## SERVICE BULLETIN

N° **139-553**

**ATA 23 - KIT RADIO MOTOROLA XiR INSTALLATION**

Rev. A of this Service Bulletin has been developed to introduce radio Motorola XiR 8268 antenna variant P/N 3G2310P04111 applicable to AW139 helicopters equipped with kit simplex tank P/N 4G2590F00513. Logistic P/N 139-553L2 has been also introduced.

**Figure 28**

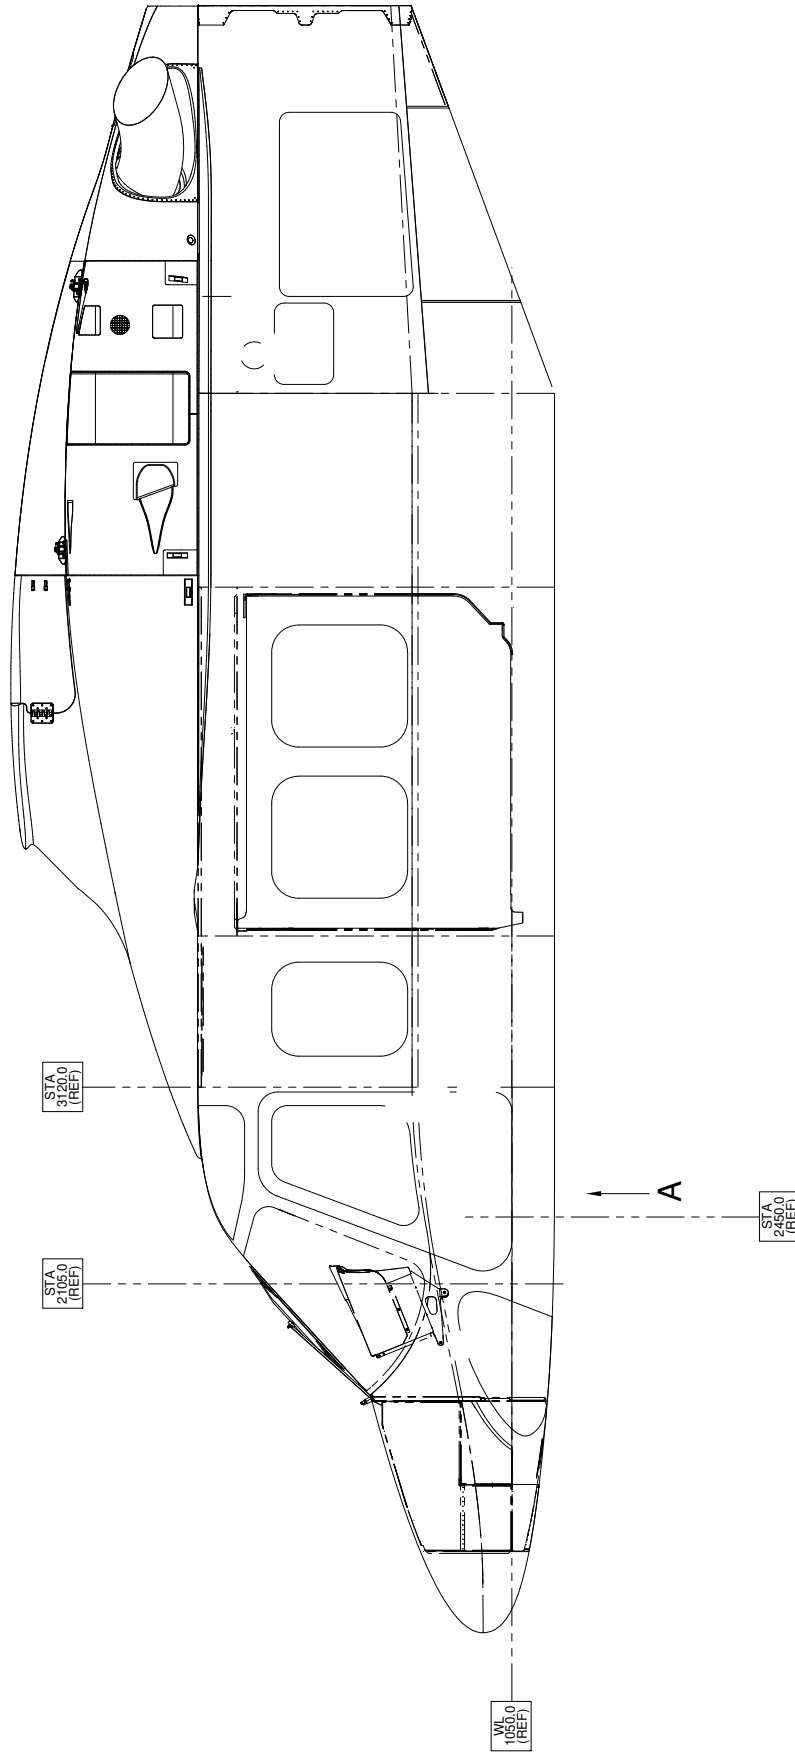
**3G5311A56111**  
**VHF ANTENNA**  
**MOTOROLA XIR 8268**  
**STRUCTURAL PROVISION**  
(APPLICABLE ONLY TO AW139 HELICOPTERS EQUIPPED  
WITH KIT SIMPLEX TANK P/N 4G2590F00513)

**Figure 29**

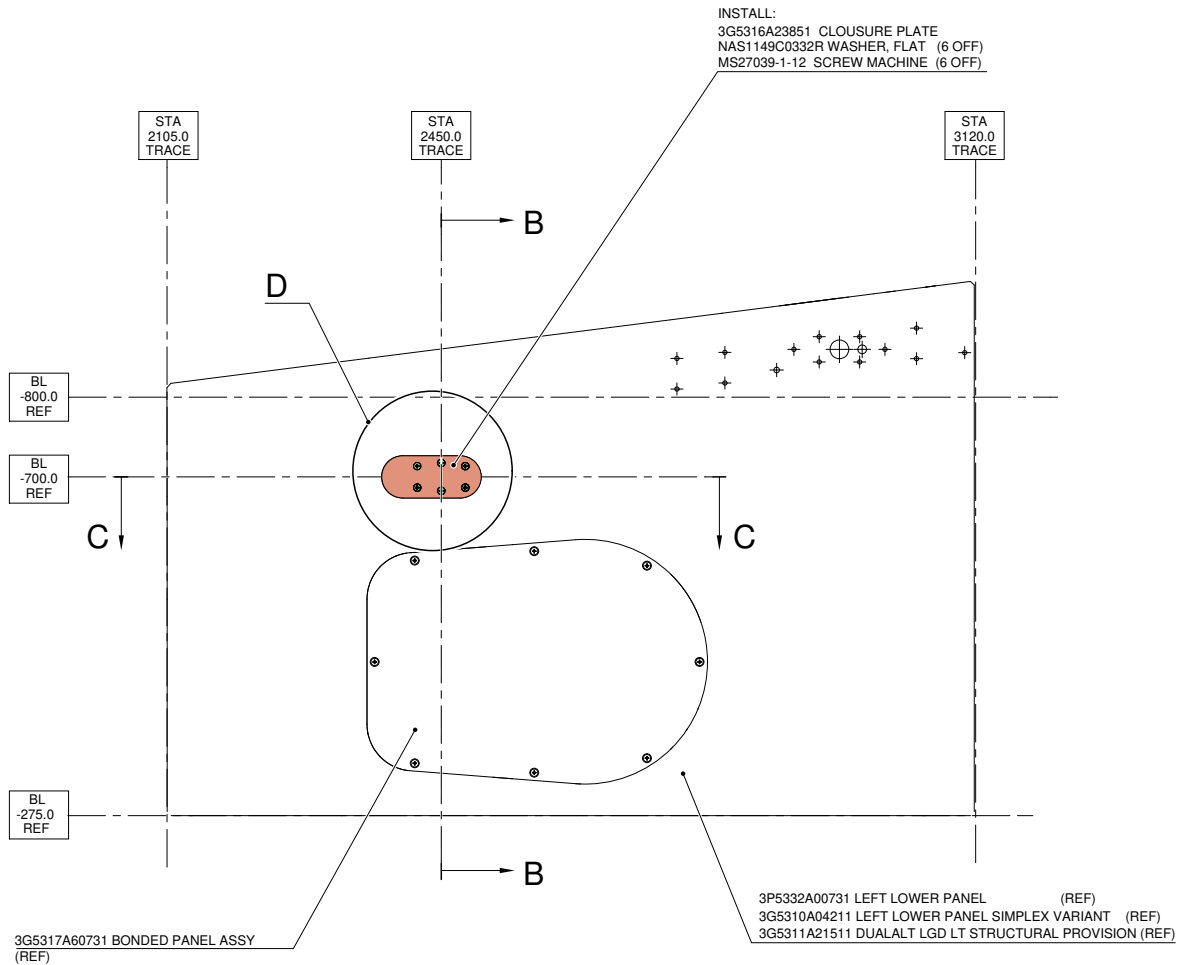
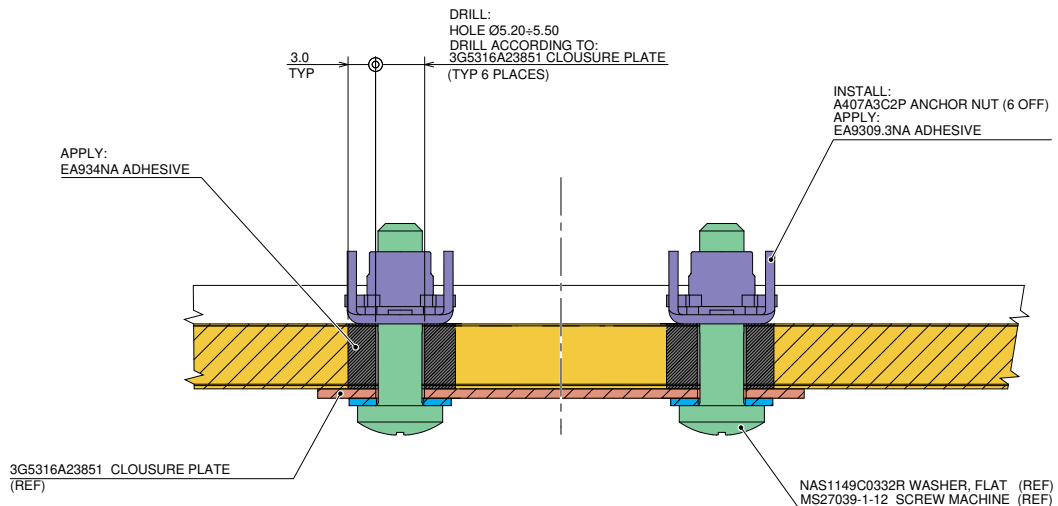
- 2.20 With reference to Figure 30 detail D, perform the indicated cut-out on the left lower panel.
- 2.21 With reference to Figure 30 section C-C, apply adhesive EA934NA (C057) on the edge of the cut-out.
- 2.22 With reference to Figure 29 view A, temporarily put in place on the left lower panel the closure plate P/N 3G5316A23851 and countermark the positions of n°6 anchor nut holes.
- 2.23 With reference to Figure 29 section B-B, drill n°6 holes  $\varnothing$  5.20 ÷ 5.50 thru left lower panel in correspondence of previously marked positions.

- 2.24 In accordance with CSRP DM CSRP-A-51-43-02-00A-921A-D and with reference to Figure 29 section B-B, install n°6 anchor nuts P/N A407A3C2P by means of EA9309.3NA adhesive.
- 2.25 In accordance with AMP DM 39-A-20-10-01-00A-259A-A and with reference to Figure 30 detail D, prepare the indicated area to assure the correct electrical bonding.

- 2.26 With reference to Figure 29, install the closure plate P/N 3G5316A23851 by means of n°6 screws P/N MS27039-1-12 and n°6 washers P/N NAS1149C0332R.

**Figure 32**

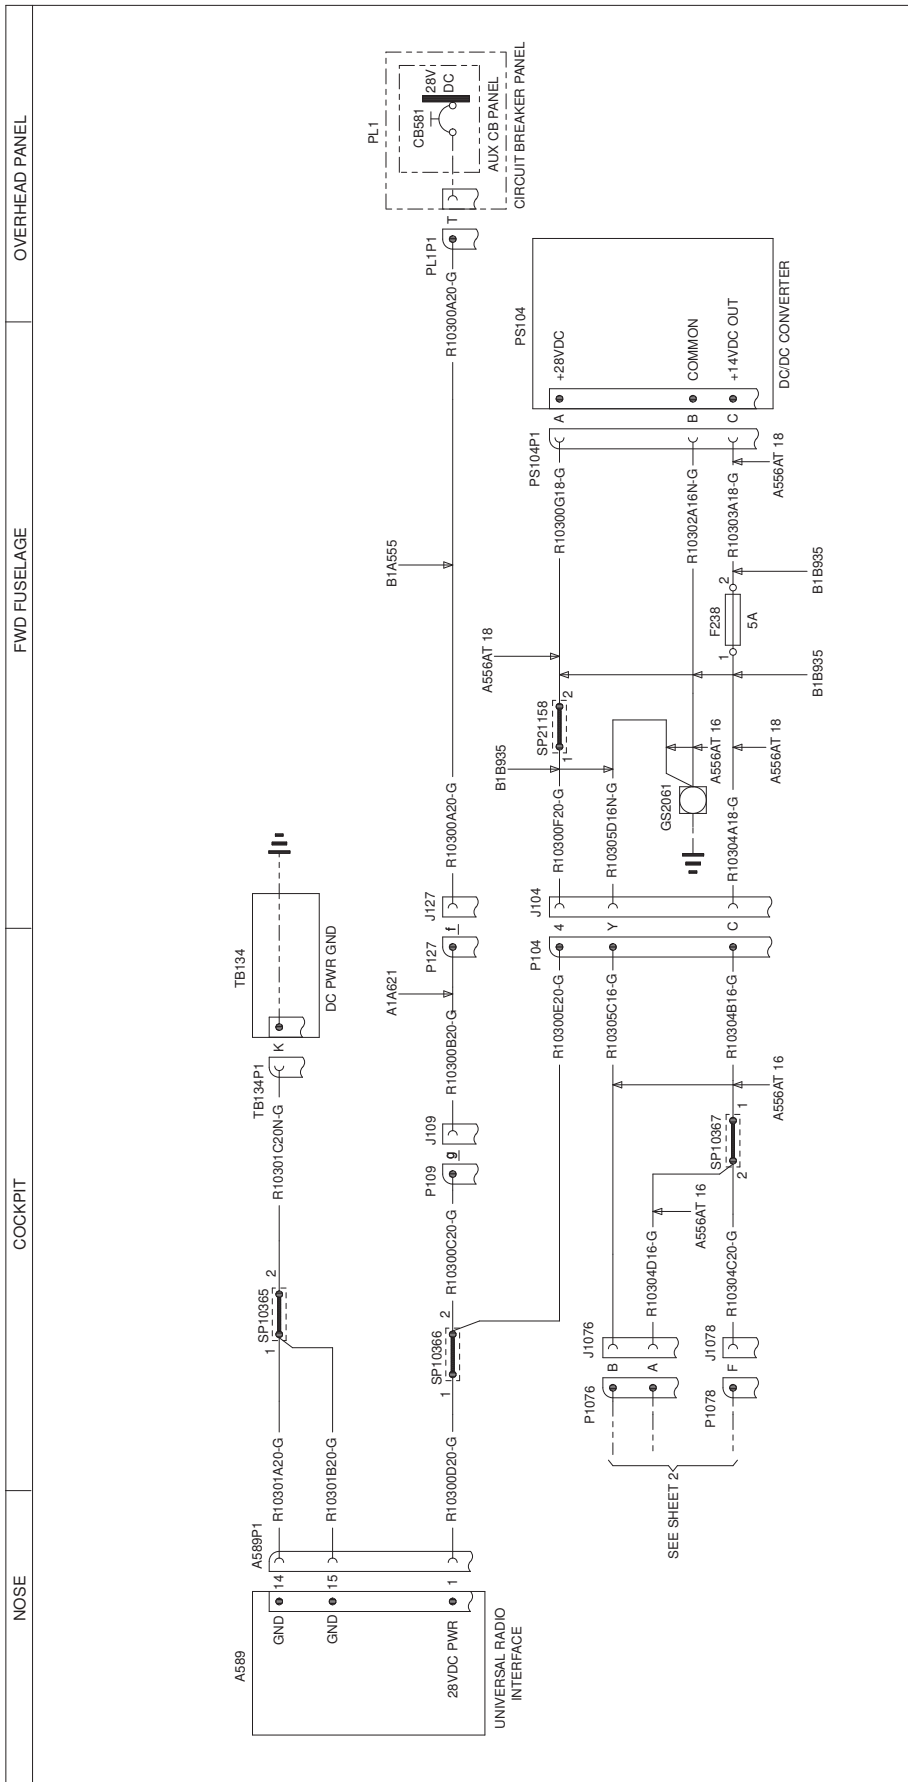
- 3.17 With reference to Figure 32, at positions n°13-14-15 install n°3 spacers P/N A631A01A and n°3 grommets P/N AW002FT102.
- 3.18 With reference to Figure 32, at positions n°16-17-18-19-20-21 install n°6 spacers P/N A631A01A and n°6 grommets P/N AW002FT102.

- 3.37.1 With reference to Figures 22, 32 and Figure 35 wiring diagram, cut n°1 wire P/N M17/60-RG142 of adequate length and lay down between UHF antenna connector E163P1 and R/T Motorola XiR connector PL199P1.

- 3.37.2 With reference to Figures 21, 22, 32 and Figure 35 wiring diagram, perform the electrical connection of C/A B3B282 between UHF antenna connector E163P1 P/N M39012/01-0503 and R/T Motorola XiR connector PL199P1 P/N 81-115-RFX. Use n°2 insulation sleeving P/N M23053/8-007-C.
